DESIGN DS	DRAWN BY DS	DART AEROSPACE LTD VICTORIA INTERNATIONAL AIRPORT, CANADA	
CHECKED <i>[Signature]</i>	APPROVED <i>[Signature]</i>	DRAWING NO. DEO 9097	REV. A SHEET 1 OF 1
DATE 97.12.14		TITLE 204/205 SKIDTUBE DRILLING CHANGE	SCALE NTS

DART ENGINEERING ORDER

TO AMEND DWGS : D2580 REV. B
D2590 REV. B
D2596 REV. B
D2597 REV. C

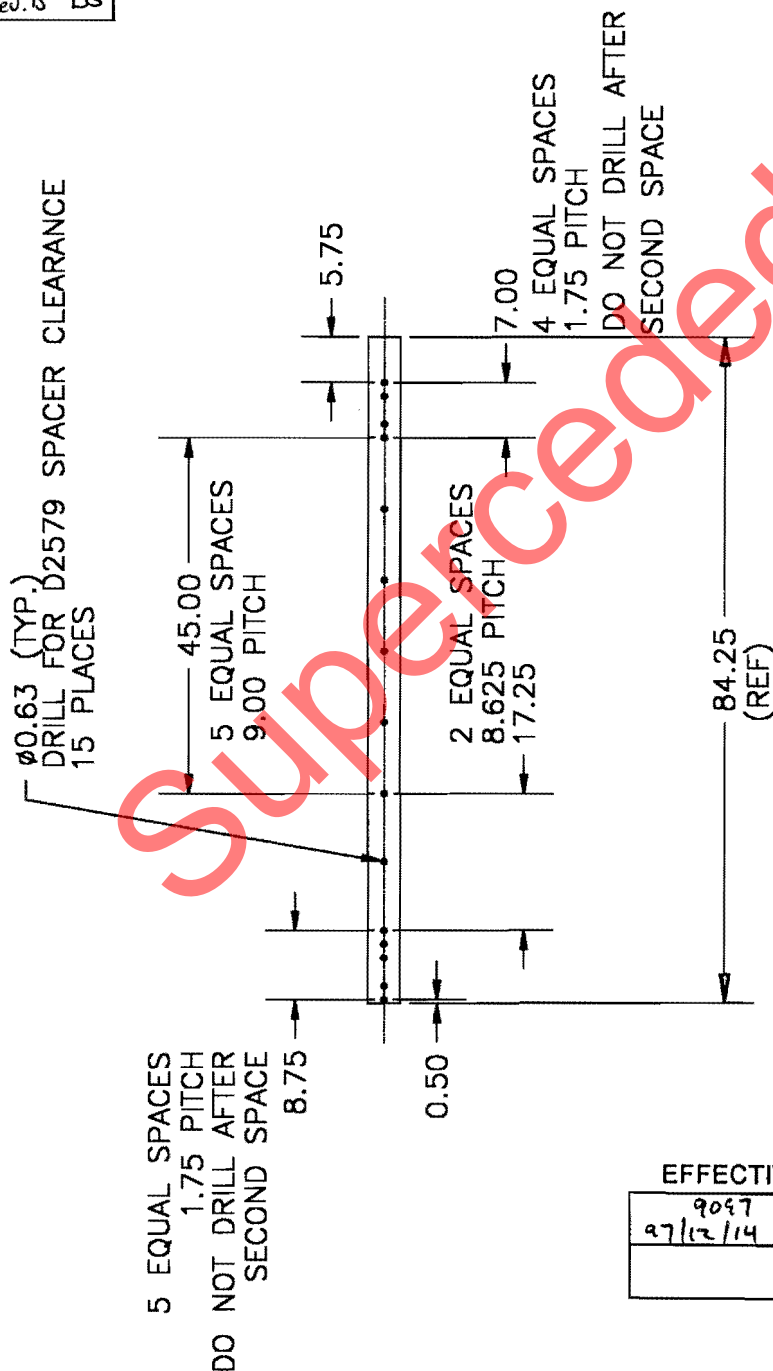
DESIGN <i>[Signature]</i>	DRAWN BY <i>[Signature]</i>	DART AEROSPACE LTD VICTORIA INTERNATIONAL AIRPORT, CANADA	
CHECKED <i>[Signature]</i>	APPROVED <i>[Signature]</i>	DRAWING NO. D2597	REV. C SHEET 1 OF 1
DATE 97.07.23		TITLE 204 WEB	SCALE 1:24
A	96.09.16	NEW ISSUE	
B	96.10.29	5.75 WAS 0.50	
C	97.07.23	Ø0.63 WAS Ø0.56

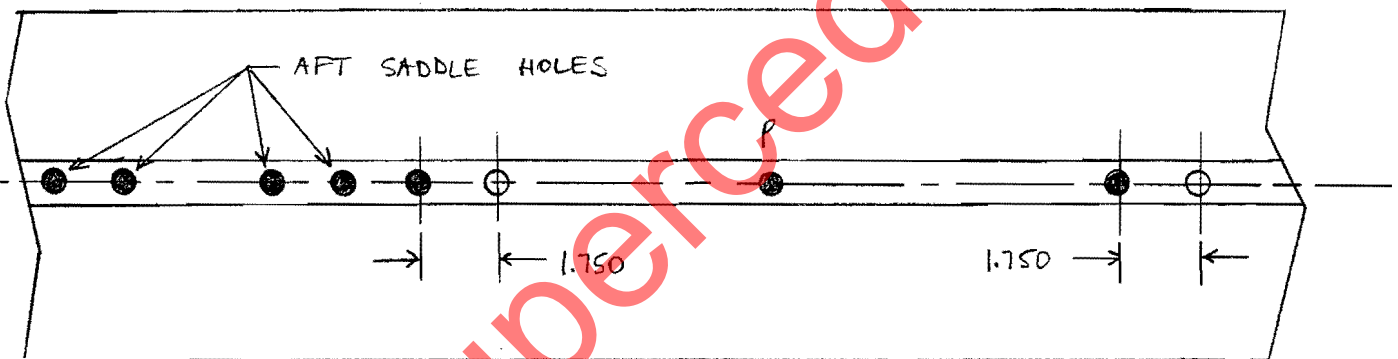
HOLE PATTERN FOR 204/205 SKIDTUBES SHOULD BE ADJUSTED
AS FOLLOWS :

NOTE : 1. ● = EXISTING HOLE
○ = NEW HOLE

- WEB HOLES SHOULD BE DRILLED TO $\phi 0.63$ AS PER DWGS D2596 / D2597 (OPEN TO 0.500 IF ASSEMBLED TUBE IS BEING MODIFIED)
- SKIDTUBE HOLES SHOULD BE DRILLED TO $\phi 0.500$ AND D2579 SPACERS SHOULD BE INSTALLED PER DWGS D2580 / D2590.
- D2594 PLUGS SHOULD NOW BE INSTALLED IN HOLE MARKED 'P' ABOVE (TOTAL NUMBER OF PLUGS INCREASED FROM 14 TO 16)
